F/YR23/0541/F

Land North of The Barn High Road Bunkers Hill Cambridgeshire

Erect 5 x dwellings (2-storey 5-bed) involving the formation of a new access

Officer recommendation: REFUSAL

Project	Proposed Residential Development	
Drawing Title	Plot 1 Floor Plans	
Address	Land North of Willock Farm Barn, High Road, Bunkers Hill	
Drawn By	Paper Size	Date
A. L. Sutton	A3	April 2022
Project Name	Drawing Number	Revision
030	002	A

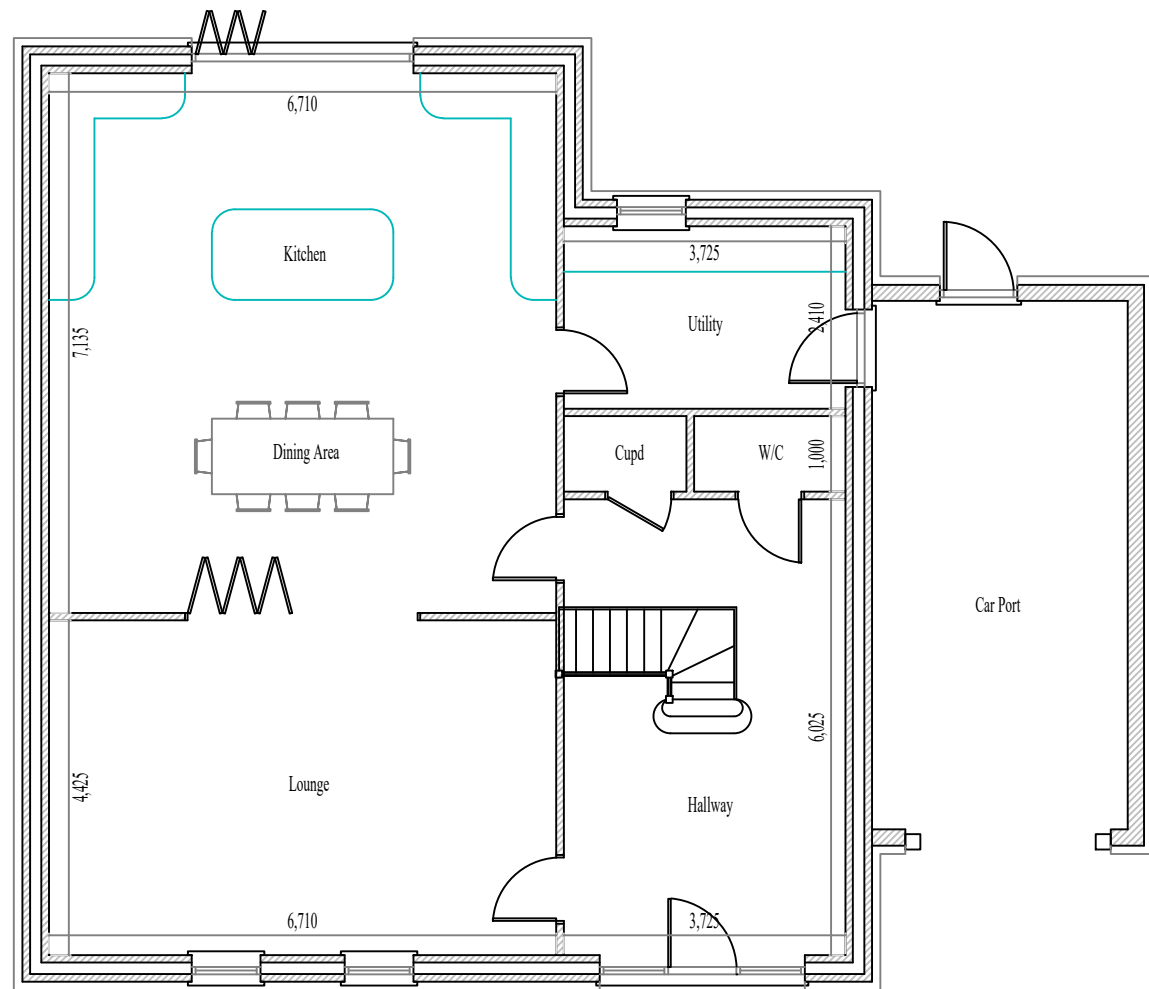
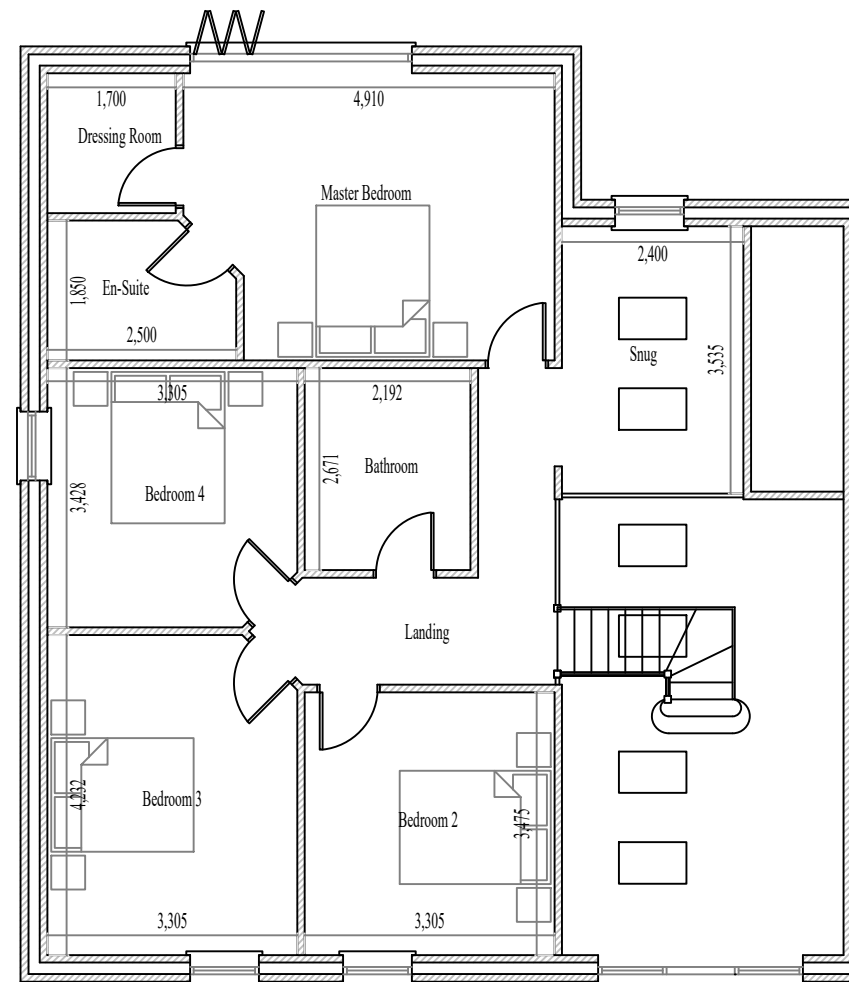
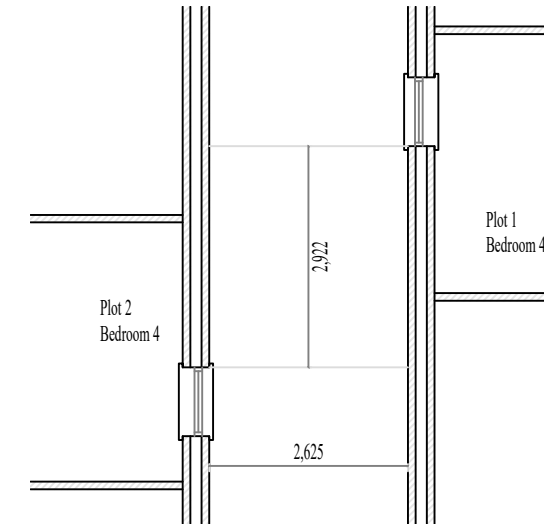
- 10.15 However, notwithstanding the above, it is considered that the proposal is detrimental to the amenity of future occupiers of plots one and two. These plots are to be separated by a gap of 2.5m. Floor plans clearly show that bedroom 4 to both plots propose one narrow window within the first floor side elevation. This will be the sole principal window to serve bedroom no4. The properties in this respect are mirrored with the windows originally proposed in line with the other which would lead to loss of privacy and overlooking.

- 10.16 Amended plans were submitted by the agent that demonstrates a re-siting of the window to bedroom 4 in plot one. Whilst it is acknowledged that the re-siting would overcome a direct loss of privacy, this has, indeed, caused another concern. The windows to both plots will now face directly to a blank wall leading to an overbearing and oppressive outlook from bedroom 4 which in turn will restrict light to each room. Given these are the principle windows for bedroom 4, the positioning of such would fail to comply with LP16 which seeks to ensure development does not adversely impact on the amenity of neighbouring properties. This matter could not be addressed through a requirement that the windows in question are constructed from obscure glass, as this would be harmful to the occupants of both plots.

- 11.3 By virtue of the siting and proximity of the windows serving bedroom 4 to both plots one and two, would create an overbearing impact upon the occupiers and therefore fail to comply with policy LP16 of the Local Plan

Revision	Description	Date	Revised By
A	Bedroom 4 window position revised	18/09/23	A. Sutton
